Docket No. 50-461

Subject: Clinton Power Station
Proposed Amendment of Facility
Operating License No. NPF-62

As a result of emergent events which have occurred at Clinton Power Station (CPS), Illinois Power (IP) requests a Technical Specification change pursuant to 10CFR50.91(a)(5). This request consists of a proposed change to Technical Specification 3/4.4.3.1, "Reactor Coolant System Leakage - Leakage Detection Systems," which is being proposed in response to inoperability of the drywell floor drain sump flow rate monitoring instrumentation. As repair of this instrumentation requires a plant shutdown, this proposed change would allow continued plant operation until the first time the plant is required to be brought to COLD SHUTDOWN.

Figure 3

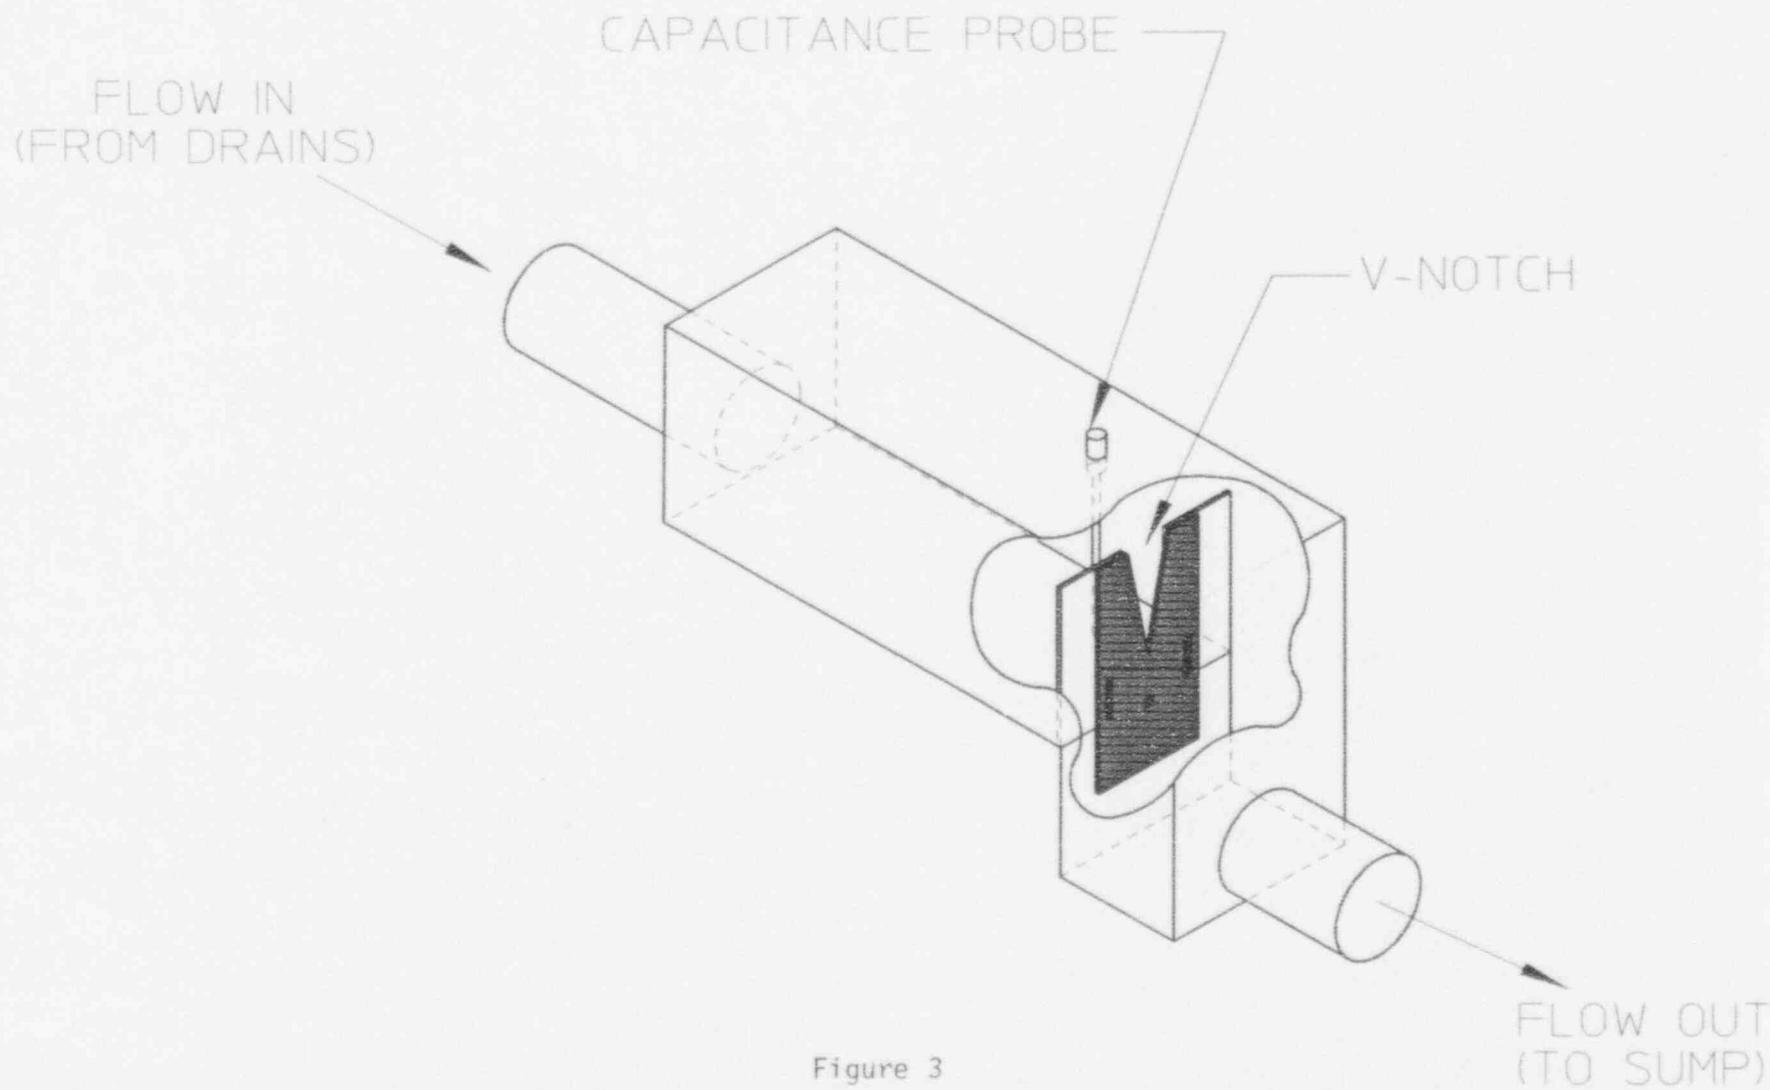
The drywell sump flow monitoring system at CPS consists of two subsystems wherein a monitoring system is provided for each of two sumps, the floor drain sump and the equipment drain sump. Each subsystem consists of a V-notched weir box with a capacitance-type probe that senses the V-notch water level. (The weir box is situated between the drains and the sump. See Figures 1, 2, and 3.) The V-notch water level is directly proportional to the flow through the weir box, which in turn is equal to the sump inlet flow rate. Each subsystem includes a recorder (which includes an indicator) and an alarm which will actuate when the flow rate exceeds a certain value. Also included is a digital flow totalizer which provides an integrated flow that can be utilized to determine average sump flow rates. This system of components (see Figure 4, which depicts one subsystem) is the system normally used to monitor sump flow and is the system required to be OPERABLE by Technical Specification 3/4.4.3.1 for monitoring the drywell floor drain and drywell equipment drain sump flows. It should also be noted that, with respect to the monitoring of UNIDENTIFIED LEAKAGE, this is the only system at CPS that meets the accuracy requirements of Regulatory Guide 1.45 for drywell floor drain sump flow monitoring.

As described above, efforts to restore the drywell sump inlet flow monitoring instrumentation to OPERABLE status have included recalibration of the instrument loop and verification that the equipment external to the drywell is operating properly. In addition, IP has also "backflushed" the V-notched weir to dislodge potential foreign material. This evolution was unsuccessful in correcting the indication problem. Additional actions have been taken to troubleshoot (from outside the drywell) the instrumentation loop located inside the drywell, including installing a capacitor in place of the capacitance probe to check for any drift in the instrument loop outside containment, checking the sensor resistance and current capacitance, performing a Time Domain Reflectometry (TDR) test on the cabling in the main control room to the transmitter inside containment to determine if there are any changes in resistance, and performing a high potential test of the cable and sensor. The results of these tests indicate that the condition of the instrument loop from the main control room recorder to the transmitter inside containment is satisfactory. The condition of the probe, however, is indeterminate.

Figure 4

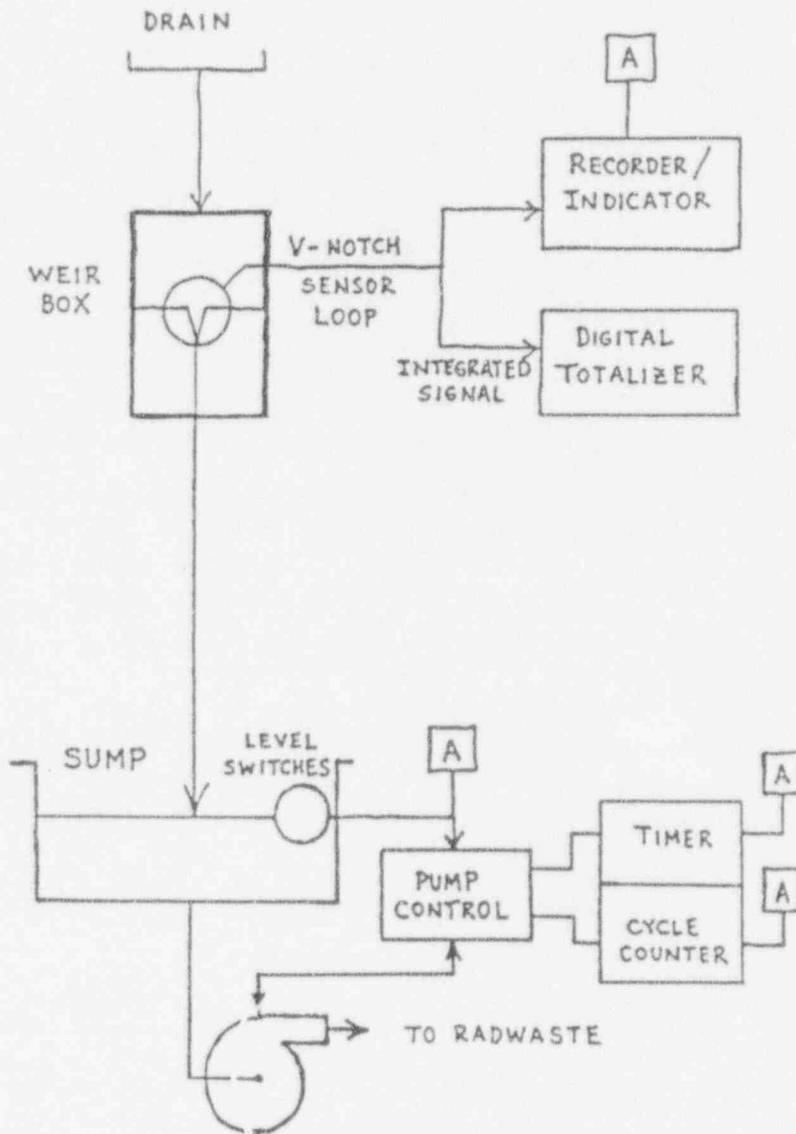
The CPS design also includes a system of pumps and pump-out timers, cycle counters and level switches for pumping collected leakage out of the sump(s). (A subsystem is provided for each sump. Again see Figure 4.) This system can be monitored to provide an average flow rate (based on the pump run times and the pump design flow rate or based on the sump fill-up times, etc.) and can thus provide a backup means for determining the average drywell equipment and/or floor drain sump flow (i.e., IDENTIFIED and/or UNIDENTIFIED LEAKAGE) over a certain time interval.

During the time period that the drywell floor drain sump V-notch weir box instrumentation is inoperable, the drywell floor drain sump flow rate will be monitored and determined utilizing the sump pump pump-out timers, cycle counters and level switches.

With the sump pump control switch in the after-start position, sump level is maintained in a narrow level band at a low level in the sump. In this mode of operation, the pumps automatically start when approximately 50-80 gallons of leakage has been accumulated in the sump. Currently, this results in one sump pump operating for approximately 1 to 1.5 minutes every five hours. Based on a rated pump flow rate of 50 gpm, the drywell floor drain sump flow rate is now approximately 0.2 gpm. Increased leakage rates would result in more frequent pump operation and thus more frequent determinations of drywell floor drain sump flow rate would be possible.
